SITE ADDRESS: 32 Loblay Crescent, Bilgola Plateau, New South Wales, 2107.

PROJECT - Addendum to Arboricultural Impact Assessment (AIA) for Mod2024/0694.

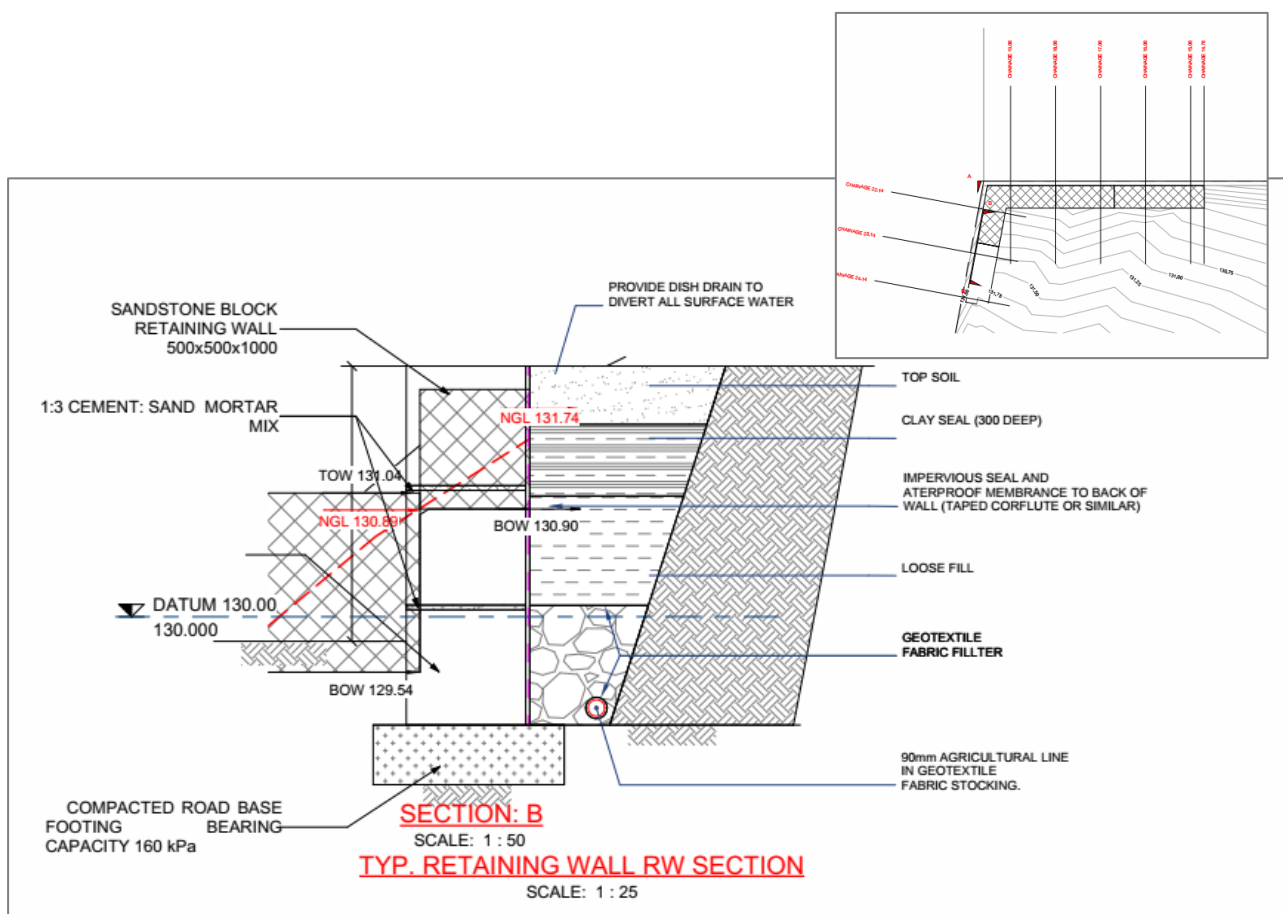
DA2023/1023 now has approved engineering plans showing details for the sandstone retaining wall (see Figure 1 below/next page). The Section Plan provides details of a compacted, roadbase footing, with a bearing capacity of 160kPa.

Additionally, the location/site plan within this drawing has the retaining wall sitting parallel to the boundary in the north-western corner. This is impractical and inconsistent retrospectively in relation to both the tree stem location and approved Site Plan, drawing no. RW DA-01B, dated June 2023 authored by Jo Willmore Designs. However, Conditions of Consent no. 14, 17, 18 and 26 direct and discuss tree protection requirements, thus potentially overriding any risk to tree roots due to this inconsistency.

Plate 1 – Sandstone wall just completed near Group 3, note minimal footing construction.

The Conditions of Consent within NOD for DA2023/1023 detail tree protection methodology and the requirement of a Project Arborist. Ideally the Engineering Design drawings would be consistent with the approved Design Drawings.

Figure 1 – Excerpt of Floor Plan, dwg no. RW DA-02D, dated December 2024, Rev D, prepared by Jo Willmore Designs. Tree/hedge marked up by C Hughes (NOT TO SCALE).

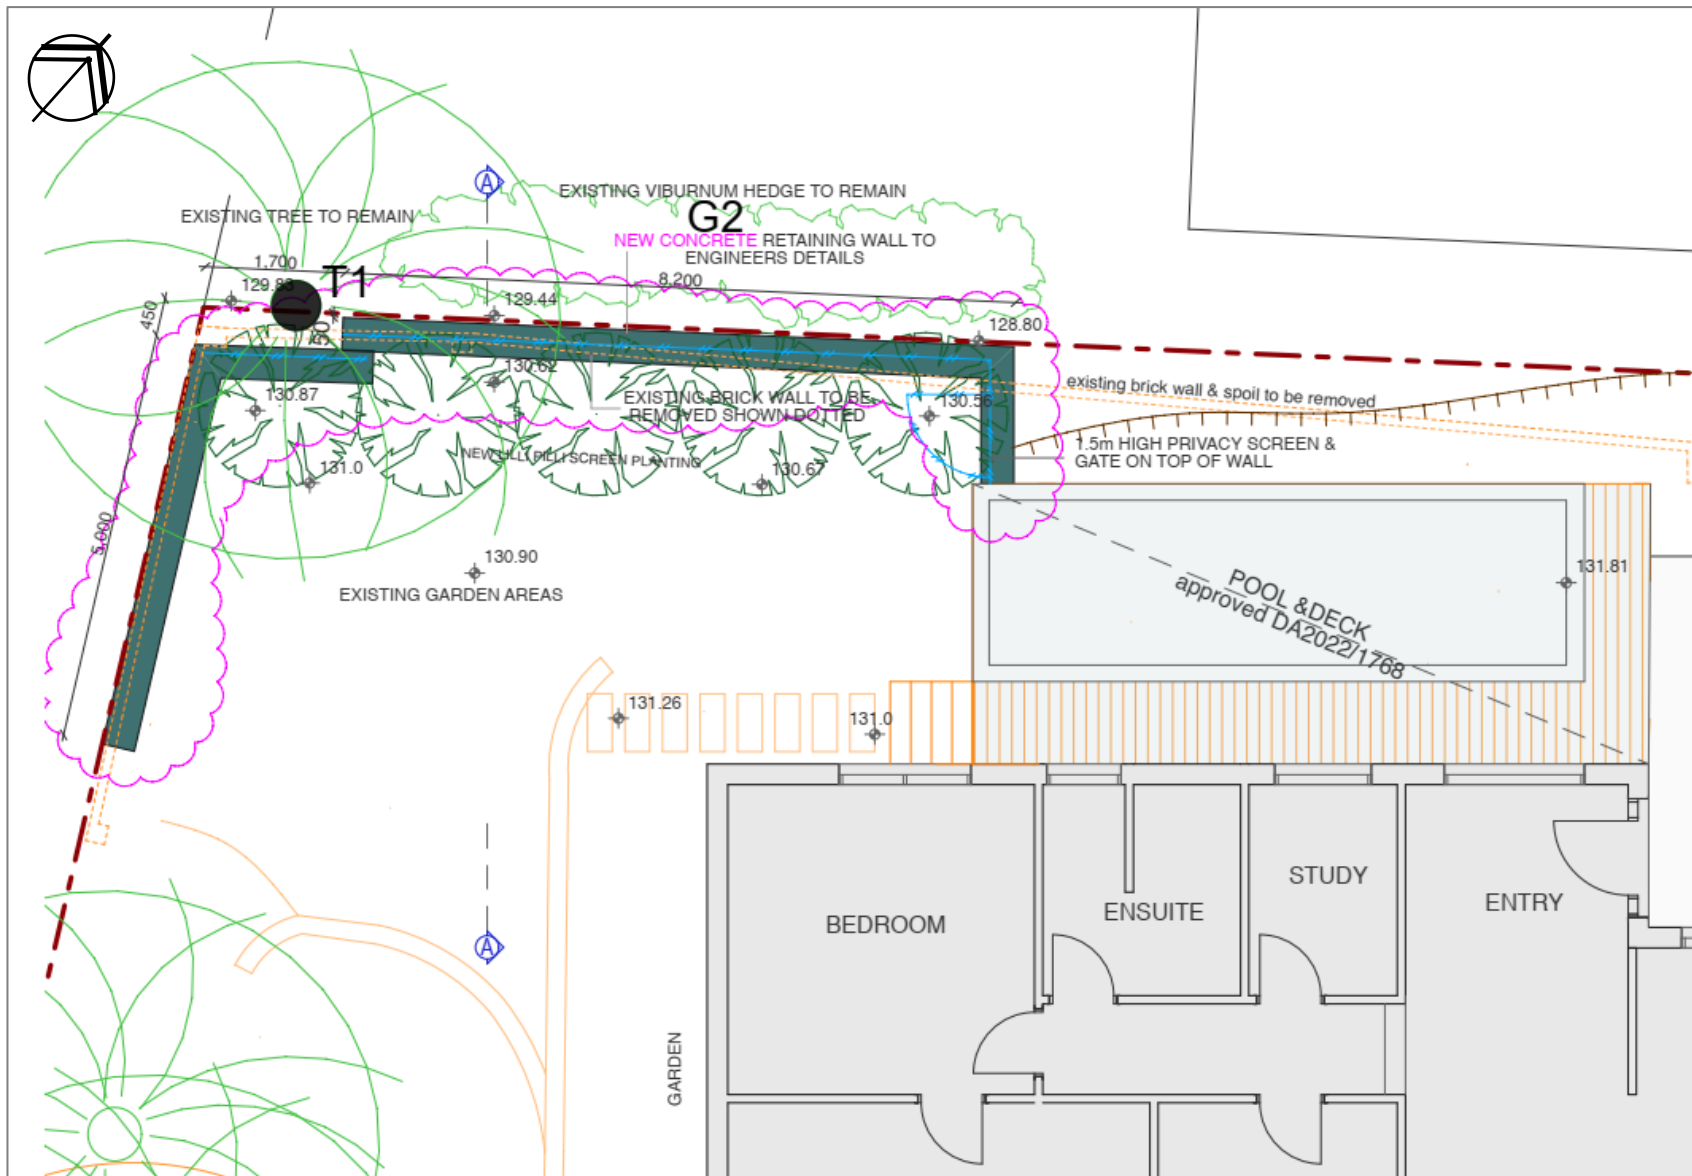
The proposed Concrete Retaining Wall appears to have the same footprint but the bearing capacity for this style wall is reduced from 160kPa to 100kPa (see Figure 2 next page). This should reduce the need for such a large footing, the front sandstone wall section (already constructed) required a minimal footing (see Plate 1 below/next page), the appointed Consultant Engineer has already provided compliance for these works.

The proposed concrete wall construction (compared to the Sandstone approved wall) will only reduce any impacts to Tree 1 and Group 2 given the above discussion.

Care will be required to line the retaining wall however, to ensure any potential lime within the poured concrete does not infiltrate/leach into the existing ground/soil. Lime significantly raised pH levels restricting plants ability to absorb necessary nutrients for growth.

Amended design of footing may still be necessary within the SRZ of Tree 1, ongoing liaison with the builder during this stage will be required, the addition of a compressible material to allow root growth is also recommended below the proposed footing but not if this requires excavation.

It is highly recommended the proposed Concrete Retaining Wall is lined prior to pouring to ensure no leachates enter the existing soil.
